BID ADDENDUM NO. 8

October 22, 2018

Johnson Student Center
Building Demolition, Increment 1 (Demolition) and Increment 2

RANCHO SANTIAGO COMMUNITY COLLEGE DISTRICT
SANTA ANA, CA

EXISTING SITE AND DEMOLITION PLAN SCALE 1" = 20'-0" 1

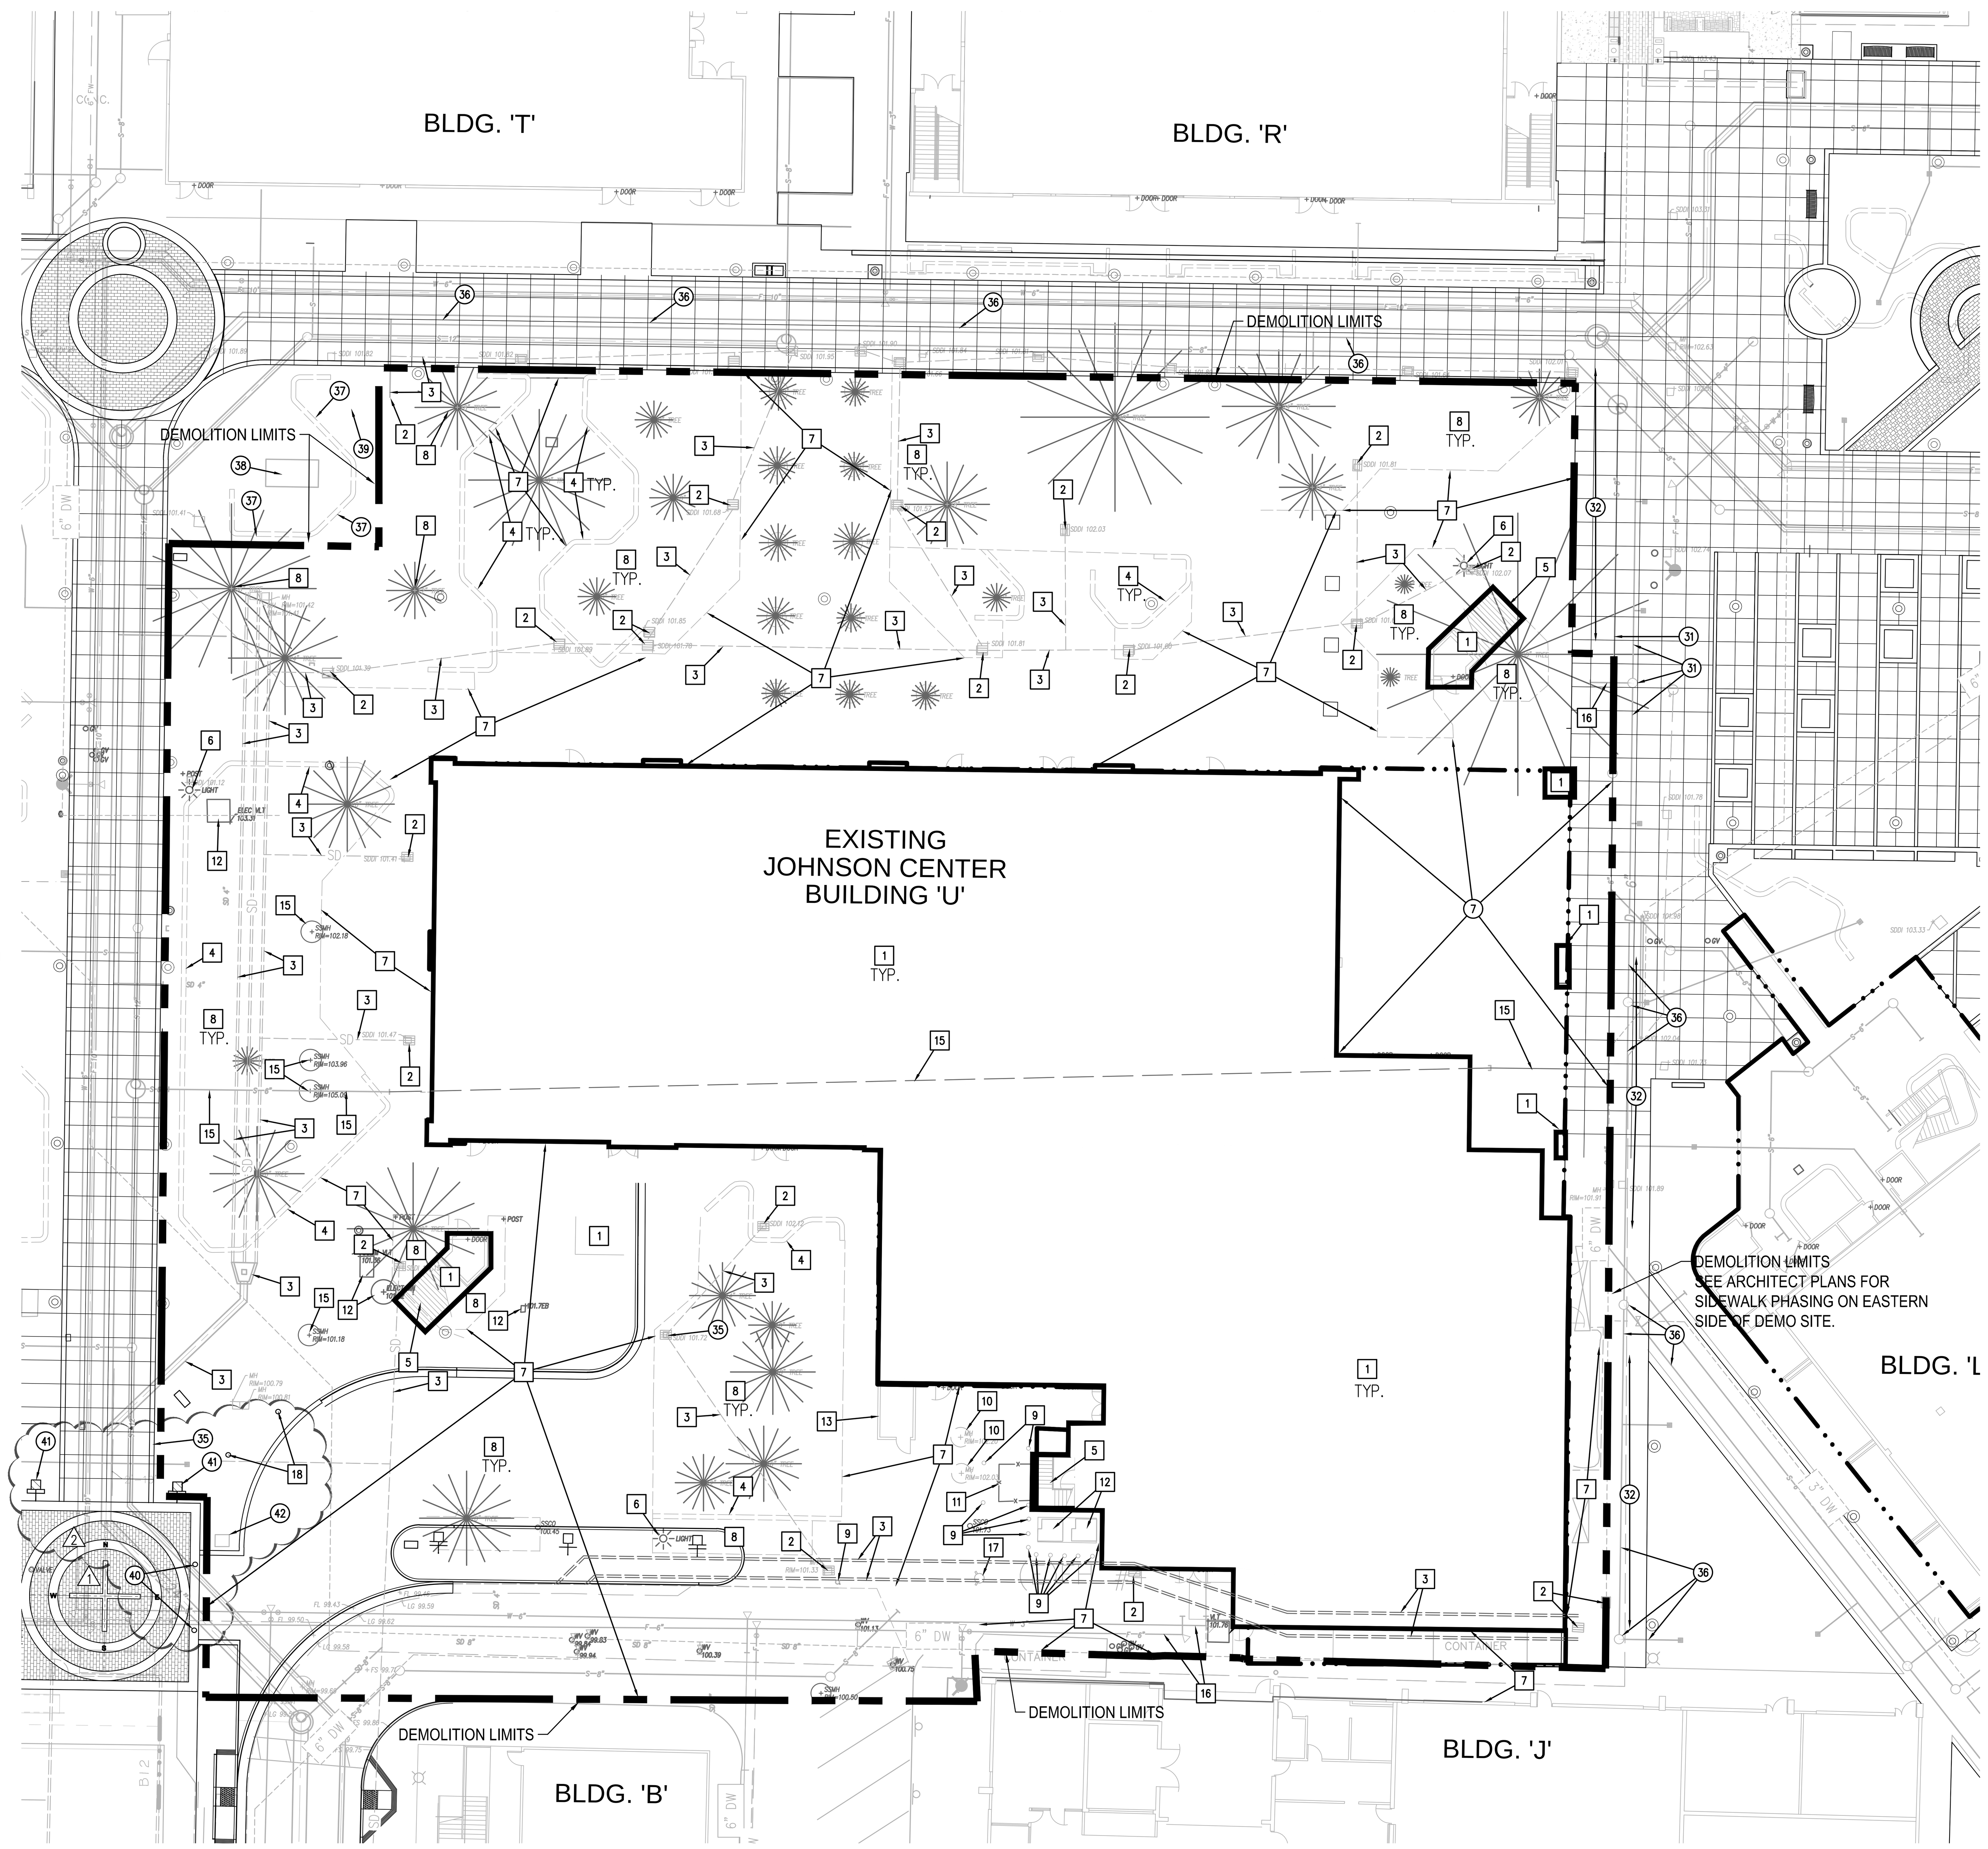
Civil:
  - Building Demolition: Revised sheet C1.00 southwest corner references of removal and protection of existing site furnishings.

FIRST FLOOR PLAN - SOUTH

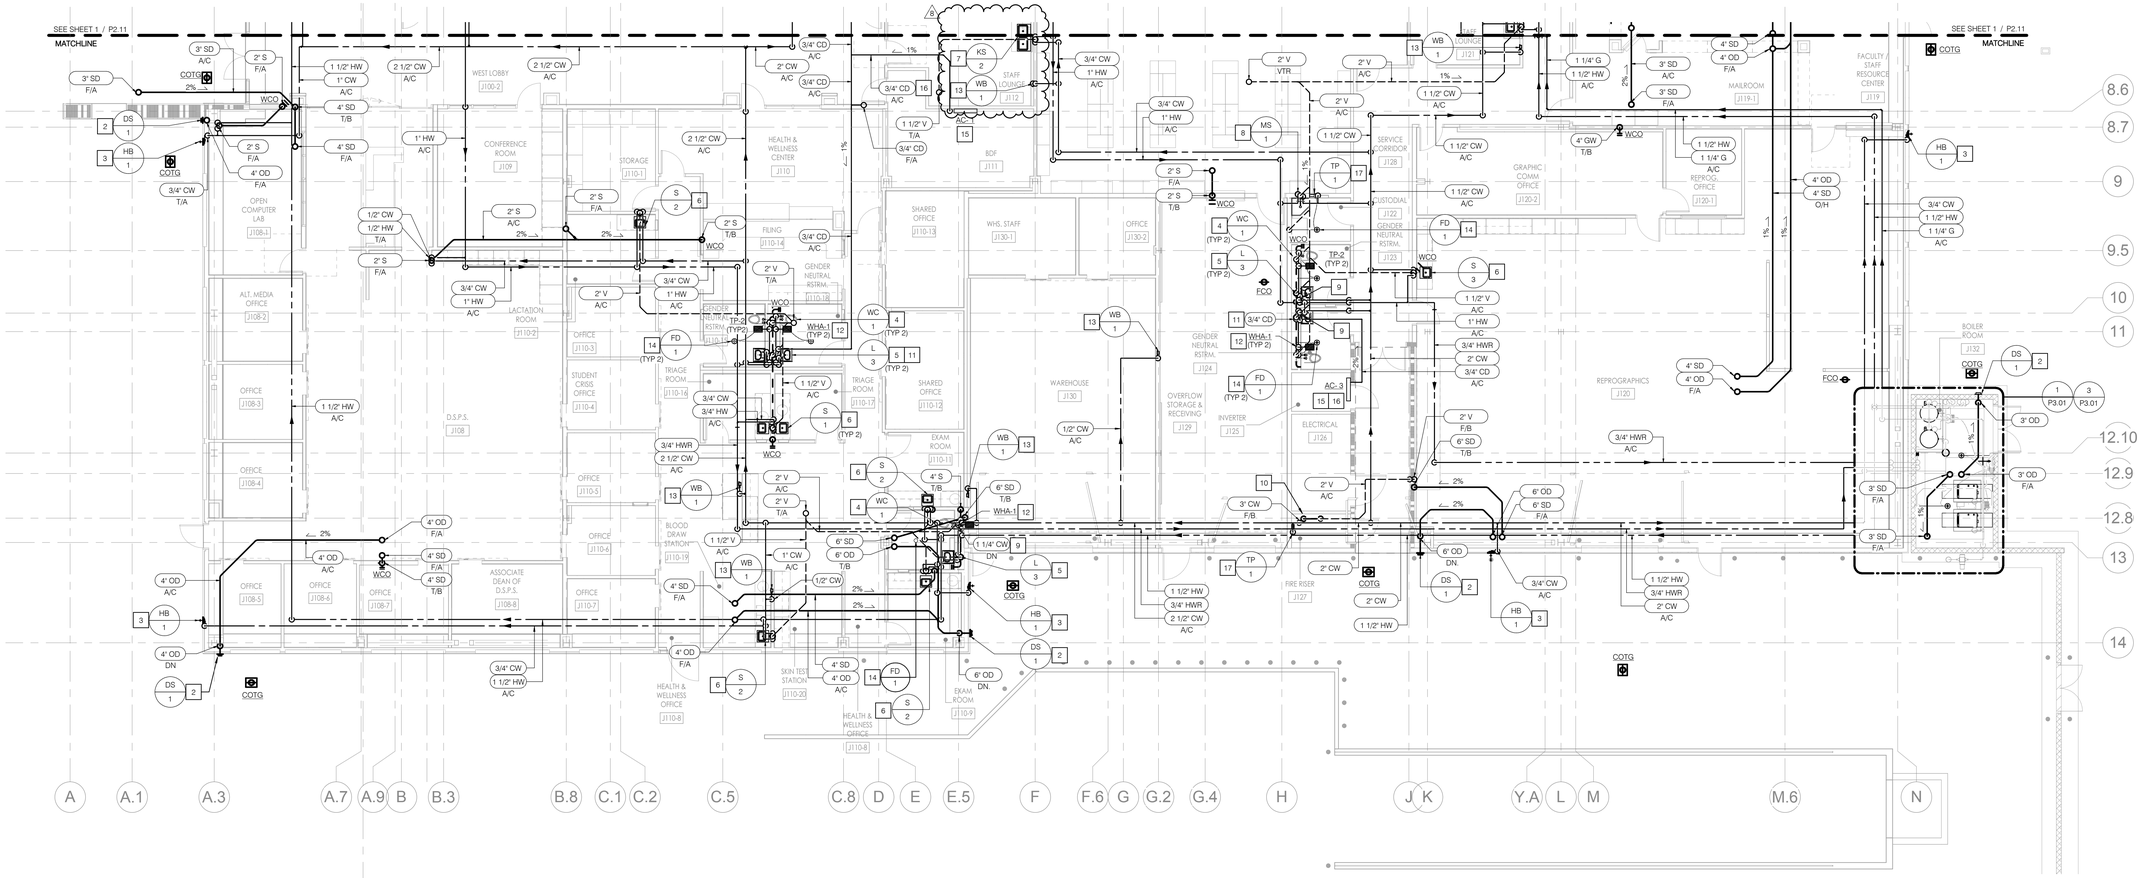
Plumbing/Electrical:
  - Increment 2: Revised single sinks to double sinks with garbage disposals. Refer to attached cutsheets KS-1, KS-2 and revised sheets P0.02, P2.12, P2.22, P3.03, E0.03, E0.11, E2.21.
